Access Compliance Report

Public Rights-of-Way

(Curb Ramps)

Intersection ID: 43666	Main Street: CORSICA_FOREST_DR	Cross Street: ASHETON_CREEK_DR	Location: SW
ADA ID: 4885916EECF3	Ramp Type: PerpDiag	Initial Pass/Fail: Fail	Overall Compliance: No
Severity Score: 21.25			
Codes/Mitigation Info/Possible Solution		Field Measurements/Component Compliance

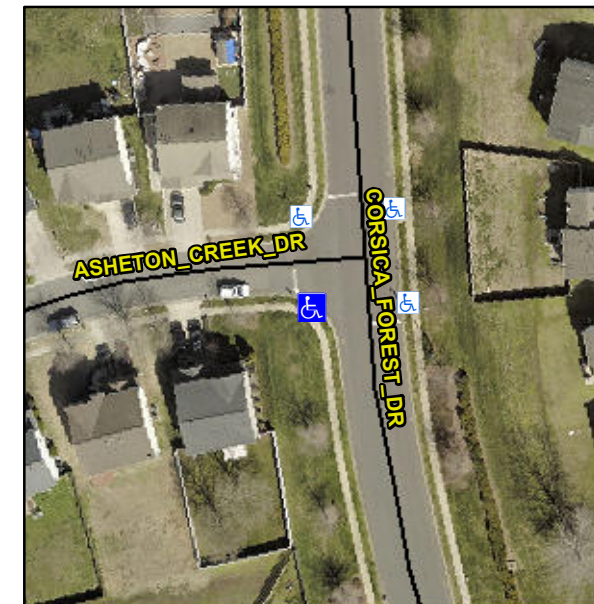
R304.5.1, R304.2.2

Compliance	Description	Data	Compliance	Description	Data
N/A	Ramp Length (in)	45.0	No	Ramp Slope (%)	9.1
No	Ramp Width (in)	41.0	Yes	Ramp XSlope (%)	0.1
N/A	Flare Type LT	N/A	N/A	Flare Type RT	N/A
N/A	Flare Slope LT (%)	N/A	N/A	Flare Slope RT (%)	N/A
N/A	Flare Traversable LT?	N/A	N/A	Flare Traversable RT?	N/A
N/A	Landing Length (in)	N/A	N/A	DWS Provided?	N/A
N/A	Landing Width (in)	N/A	N/A	DWS Contrast?	N/A
N/A	Landing Slope (%)	N/A	N/A	DWS Length (in)	N/A
N/A	Landing X Slope (%)	N/A	N/A	DWS Full Width?	N/A
N/A	Landing Curb? (Y/N)	N/A	N/A	DWS Offset (in)	N/A
N/A	Shared Landing?	N/A			
N/A	Gutter Ponding?	N/A	N/A	Gutter Slope (%)	N/A
N/A	Gutter Lip Ht (in)	N/A	N/A	Gutter X Slope (%)	N/A
N/A	Painted X Walk1?	No	N/A	Painted X Walk2?	No
	X Walk 1 Direction	To E		X Walk 2 Direction	To N
N/A	X Walk 1 Width (in)	N/A	N/A	X Walk 2 Width (in)	N/A
	X Walk 1 Slope (%)	0.8		X Walk 2 Slope (%)	2.6
	X Walk 1 X Slope (%)	2.2		X Walk 2 X Slope (%)	0.3

Remove & Replace Curb Ramp With Two New Directional Ramps or Equivalent.
